Subject: Submittal of report, "Effect of Environment on the Corrosion of Waste Package and Drip Shield Materials" (CNWRA 2001-03), Intermediate Milestone 01402.571.170

RESPONSES TO NRC COMMENTS ON IM 01402.571.170

“EFFECT OF ENVIRONMENT ON THE CORROSION OF WASTE PACKAGE AND DRIP SHIELD MATERIALS”

Figure 3-5. U.S. Department of Energy predicted mean dose rate as a function of time for the basecase corrosion rate, and the 5th and 9th percentile median corrosion rates is fixed at the 5th and 95th percentile values of the uncertainty variance

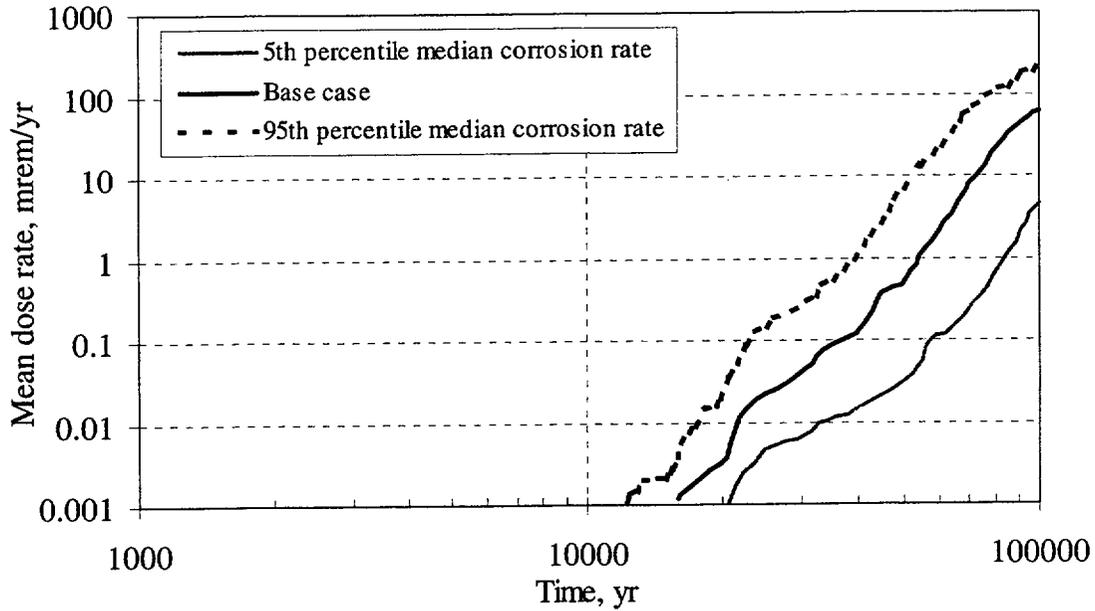
8. **Page 3-12. 2nd paragraph. Last sentence. “and the maximum dose rate at 100, 000 yr is 2×10^{-2} mrem/yr (figure 3-5).” That is 0.02 mrem/yr, not 200 mrem/yr as indicated in the figure. Should be 2×10^2 , not 10^{-2} .**

Accept, change made.

Figure 3-11. Metal ion concentrations measured using capillary electrophoresis from the anodic dissolution of Alloy 22 at 500 mV_{SCE} in 0.028 M chloride at 95 °C

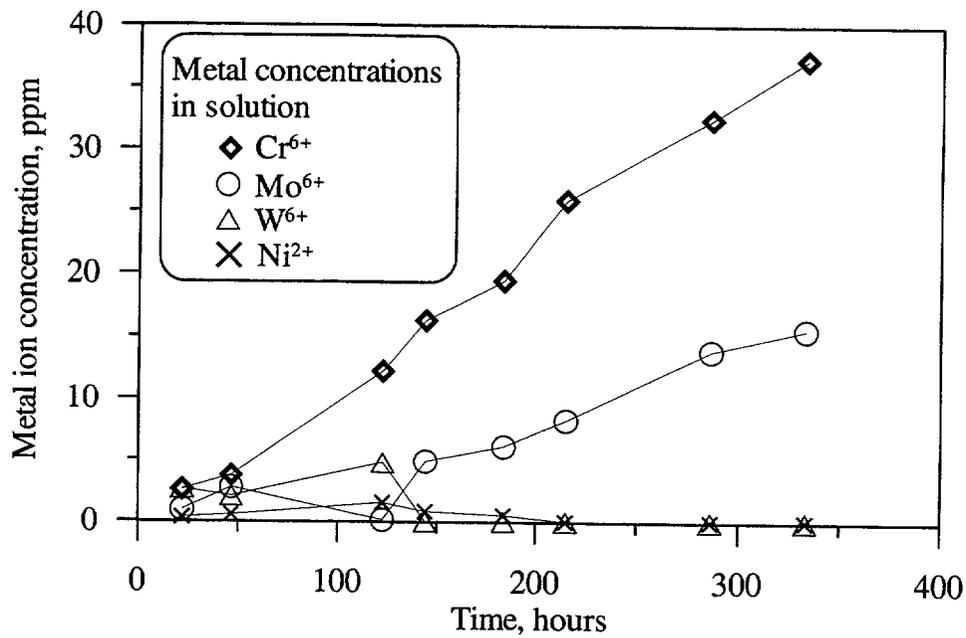
10. **Page 3-22. Figure 3-11. Graph label typo on X-axis.**

Figure 4-5. Predicted drip shield failure times using WAPDEG for the basecase (mean), and enhanced (5th percentile) and degraded (95th percentile) drip shield cases (Civilian Radioactive Waste Management System Management and Operating Contractor, 2000h)

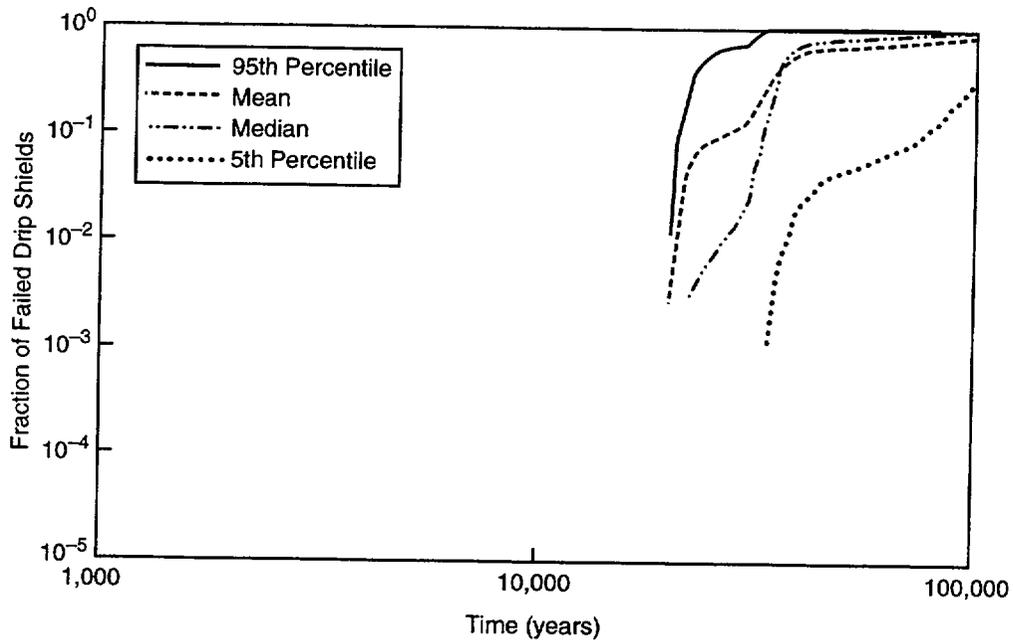
15. **Page 4-8. Figure 4-5. The graph cannot stand alone. The legend needs addition information. Suggest adding Degraded case to 95th percentile and Enhanced Case to 5th percentile. The chart is explained in the text, but the chart alone is insufficient.**

Accept. These are, however, DOE figures and we should be careful about altering them. Consequently, no change to the figure was made but the figure caption was modified to help clarify.

Figure 4-9. Effect of fluoride on the passive current density for Ti Grade 7 over time in a deaerated, 1 M NaCl solution at 95°C and an applied potential of 0 V_{SCE}

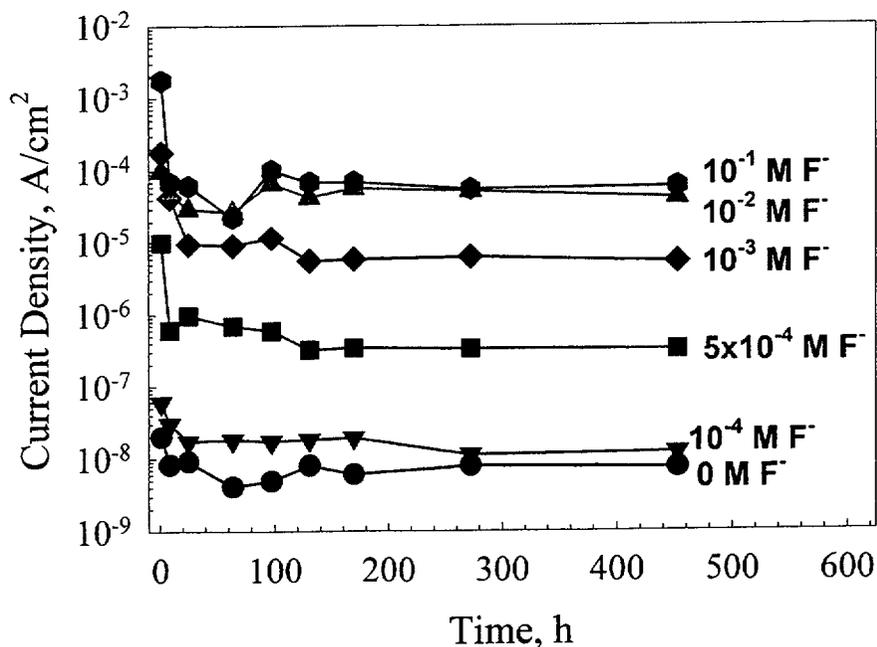
16. **Page 4-12. 1st paragraph, 2nd line. The plateau is at 10^{-2} or 10^{-1} ? It looks like 10^{-1} from the graph (figure 4-9), but I am not certain.**

The difference between 10^{-2} and 10^{-1} is relatively small and the rate of change is decreasing sharply between these concentrations. Thus, even though a slight increase in the passive current density was observed when the fluoride concentration was increased from 10^{-1} to 10^{-2} it seems more likely that the start of the plateau is at or very near 10^{-1} .

Figure 4-19. Cathodic polarization of Ti Grades 2 and 7 in a simulated crevice solution of 5 M NaCl, 0.1 M HCl, at 95 °C

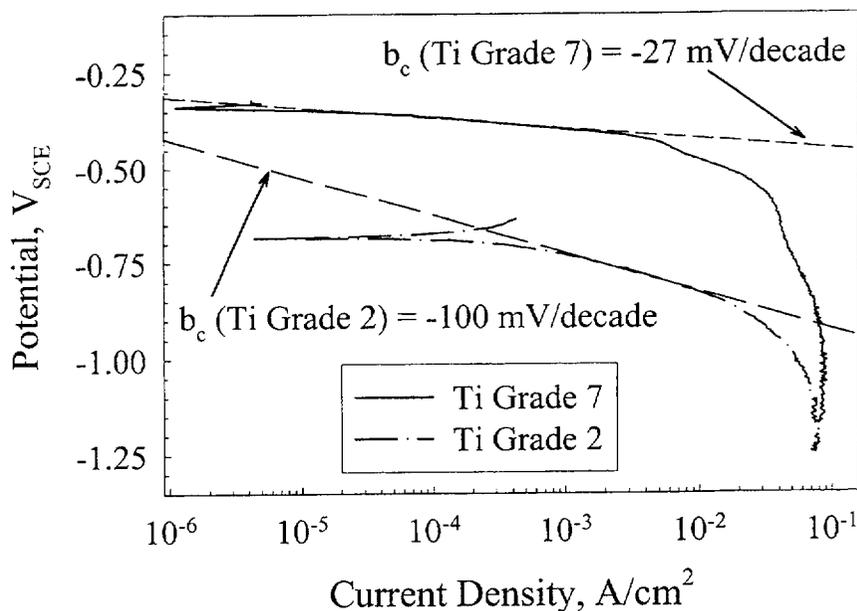
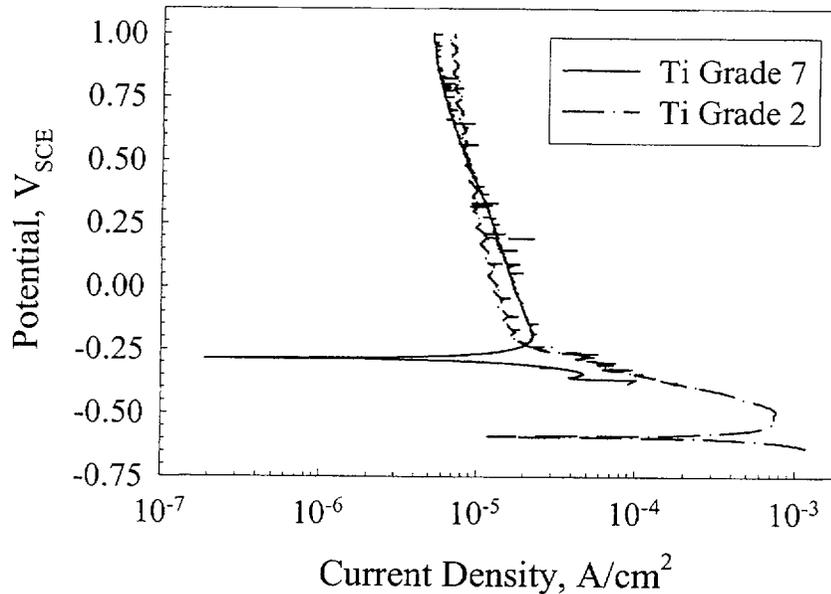
31. **Page 4-19 Numbering problem -- Figures 4-19 and 4-20, not 4-18 and 4-19 (also page 4-20, Figure 4-19, not 4-18).**
